Rock Creek Hiker-Biker Trail Bridge

Public Meeting Comments

**ROCK CREEK HIKER-BIKER
TRAIL BRIDGE**

**FACILITY PLAN
TECHNICAL REPORT**

ALTERNATIVE 5

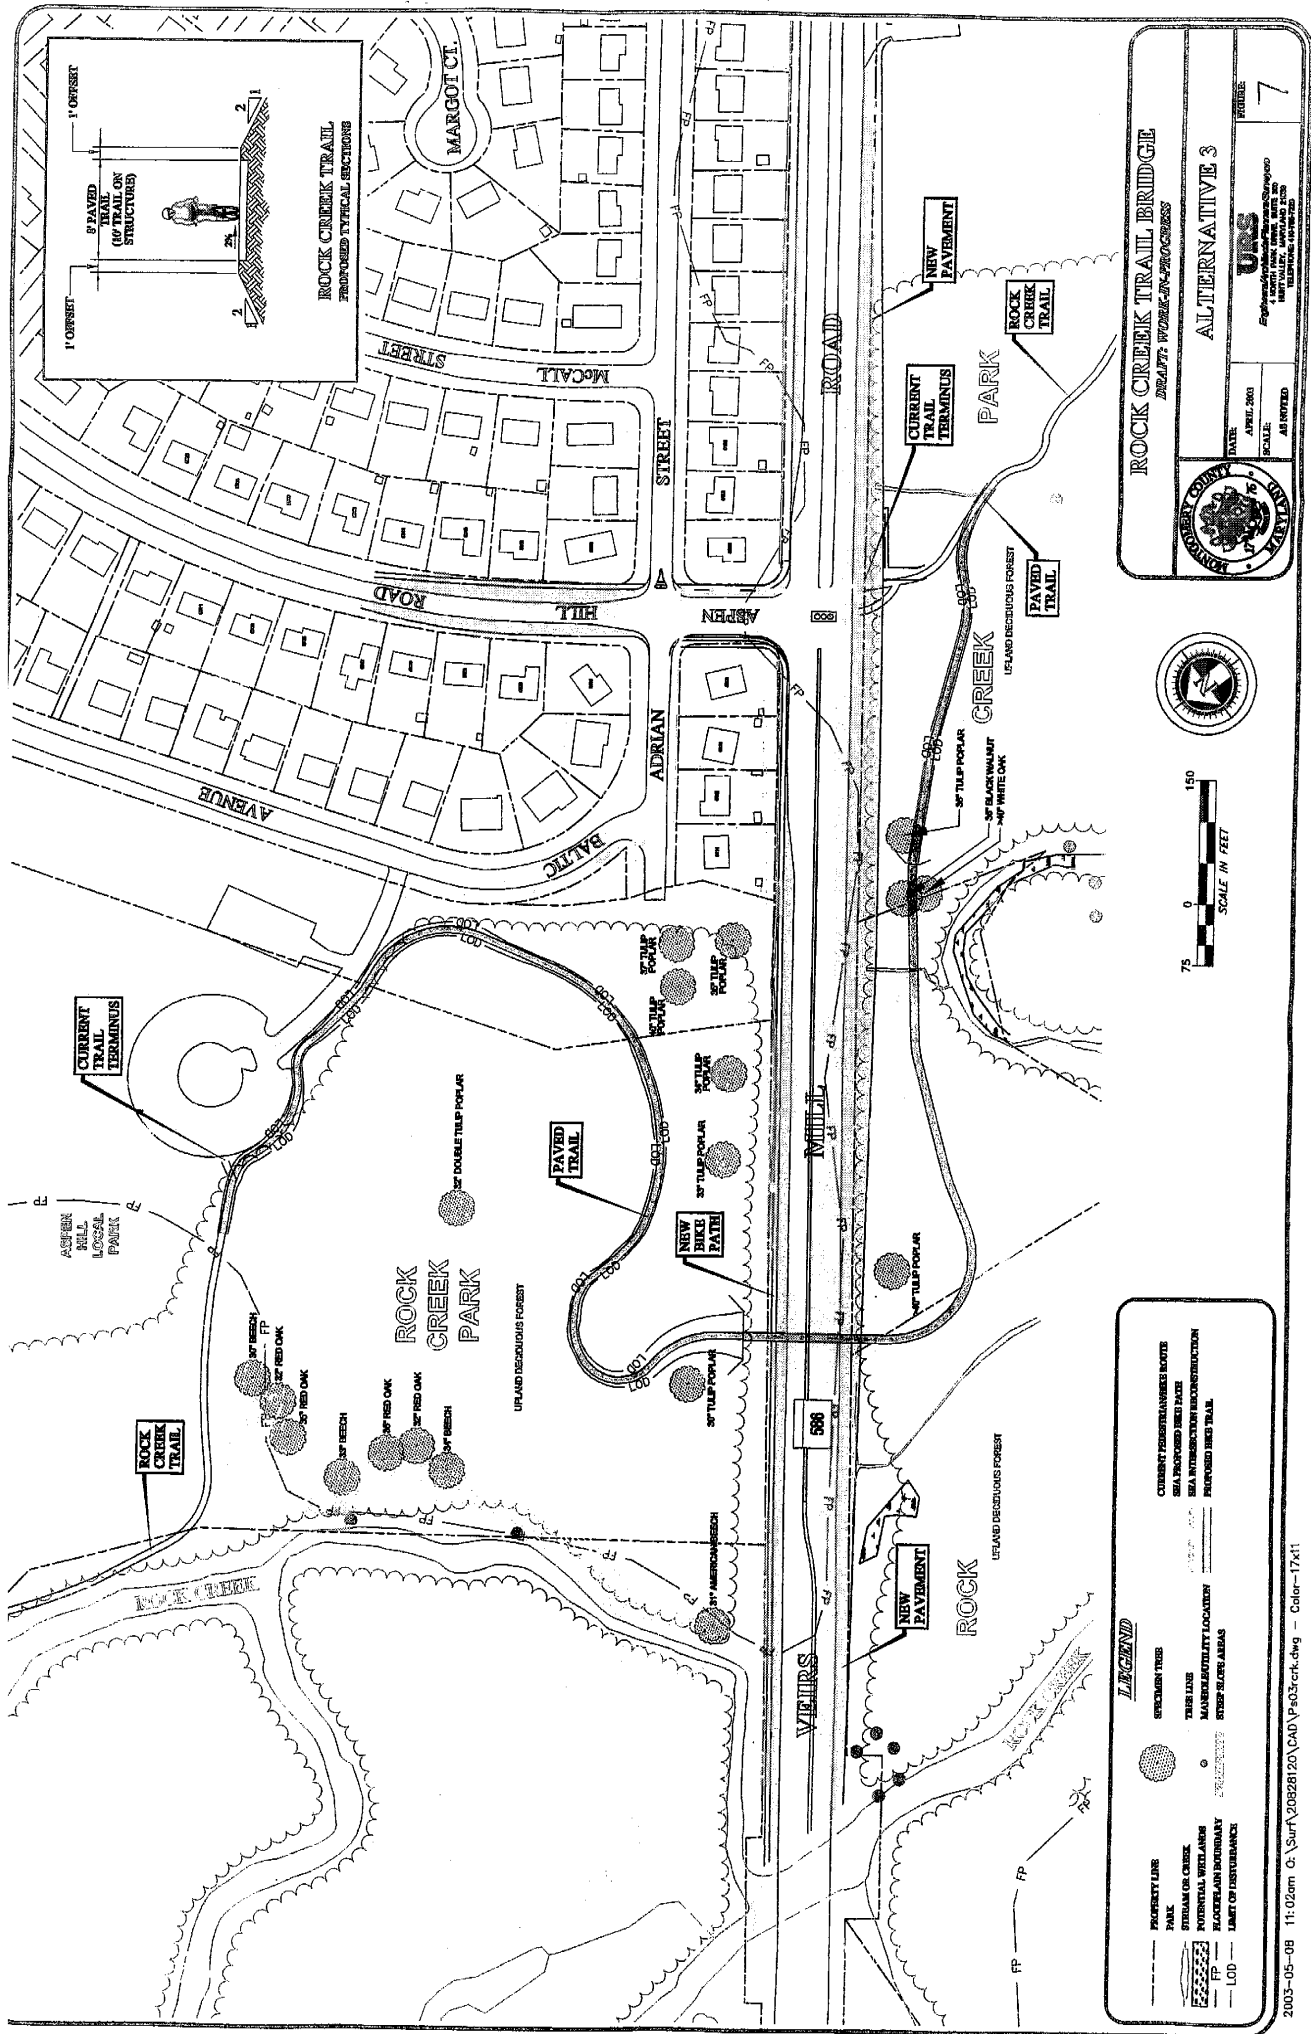
TOPIC	COMMENTS	RESPONSE	ACTION ITEMS
1. Bridge over Veirs Mill Road	How close is the bridge to the nearest property and residence at 5114 Adrian Street? Is the bridge is too close? Can it be moved farther away?	The bridge as proposed is approximately 85' from the property line and 130' from the adjacent residence. The bridge needs to be reasonably close to the intersection to be worth using by pedestrians and bicyclists, and especially for the transit stops. It has been located away from the adjacent property to the extent possible to minimize	<i>M-NCPPC should establish a meeting with the homeowner in the field as soon as possible to review the new alignment and obtain any additional concerns. The homeowner at 5114 Adrian Street is, Fidel Granados at 301-946-2570, cell is 301-252-</i>

environmental impacts and to service the neighborhood pedestrians and transit users.	2946.
2. Bridge	Will the bridge be visible from the adjacent property? The bedrooms of two young girls face the bridge site, and trail users should not be able to look into the house. The adjacent homeowner does not want screening of landscape plant material and is concerned that it may attract homeless to set up camp between the landscape screening and the bridge.	The Design team can work with the adjacent homeowner regarding additional landscape screening possibilities for the view of the bridge from the house.	<i>After further discussion of the homeowner's concerns, the design team should look at alternative means (possibly structural) to screen views to the house from the bridge.</i>

3. Bridge	Will the bridge be designed to support snow removal trucks? The park needs to be able to plow the bridge after snowfall.	The bridge will be designed for H-10 loading which will accommodate light maintenance vehicles, such as pickup trucks. M-NCPPC does not perform snow removal on their trails from a maintenance standpoint. However, for transit users there may be a need for snow plowing. Snow would have to be removed from the bridge, as snow can not be pushed/blown through the barrier fence to the road below.	<i>M-NCPPC, the Park Manager, Montgomery County, and related transit authorities to discuss how snow plowing will be handled, and who will perform the work.</i>

4. Bridge	Please coordinate with police so that they can provide input on their needs. Police need to be able to drive on path through park. Can a police vehicle cross the bridge?	The bridge will have 12' wide inside clearance. A police cruiser would be able to cross the bridge. Placement of bollards at the bridge entrances is not a standard practice by the M-NCPPC, and they are a safety issue with bicyclists.	<i>M-NCPPC to discuss issues with park police to determine need for a police cruiser to cross via the bridge.</i>

5. Stair Tower	<p>Please describe the stair tower, and how far is the stair tower and the connecting sidewalk from Veirs Mill Road? Is too far away? Can it be moved closer? The stair tower should be no further than 20' from the roadway. Many trail users will be using the trail late at night and will not feel safe using the sidewalk/stair tower if it is so far from the road. The sidewalk should be along the road. The ingress/egress to the stair tower should be oriented to the roadway.</p>	<p>The stair tower would consist of about 45 to 50 steps with landings at about every 12 steps. It would consist of an open design for security concerns in order to allow for the clearest visibility to the structure.</p> <p>The path to the stair tower from the transit stop would vary from about 10' to 40' from the future edge of widened Veirs Mill Road (location of stop subject to change). The sidewalk as it is shown was set to avoid a proposed SWM ditch which will run along the widened shoulder, and to avoid existing trees. The sidewalk and tower can be moved closer to the roadway, but the ditch may be impacted. Also, moving the stair tower closer will increase the number of steps required. Too many steps may deter pedestrians from using the stair tower. The design team will look into options for setting the sidewalk and stair tower closer to the road. It was shown as well that there may be an alternative to the stair tower by connecting a path from the transit stop to the southern terminus of the bridge. The stair tower will also be subject to available construction funding for the overall project.</p>	<p><i>M-NCPPC to determine if stair tower is to be included in application for funding. Preliminary cost estimates for the stair tower are at \$40,000 however the cost may be substantially higher for all requirements, including lighting and long-term, maintenance of this structure.</i></p>
